# SERVICE BULLETIN #131

3/16/15

## 7622 Trailer Spoke Wheel

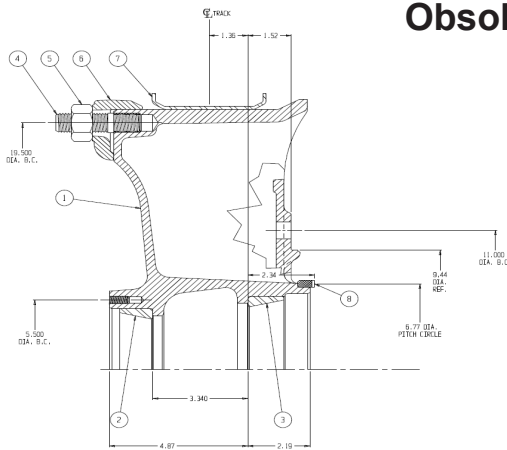
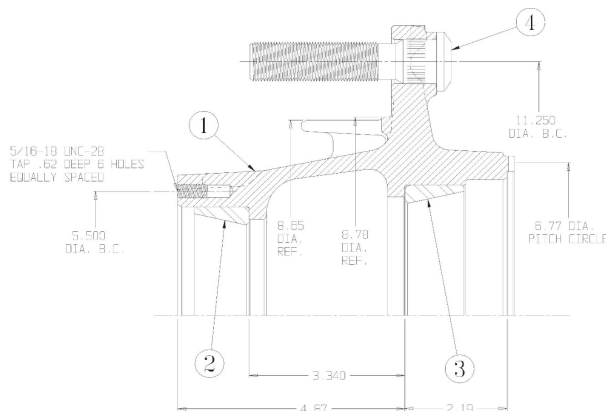
Upon depletion of inventory, the 7622 trailer spoke will become obsolete with no direct replacement. We do however recommend a replacement: the 10-stud 2023 hub. This requires changing brake drums, changing to a disc hub, and changing to disc wheels instead of demountable rims. If you have any questions, please contact Webb Technical Services via email to [engineering@webbwheel.com](mailto:engineering@webbwheel.com) or call (256)739-6660.
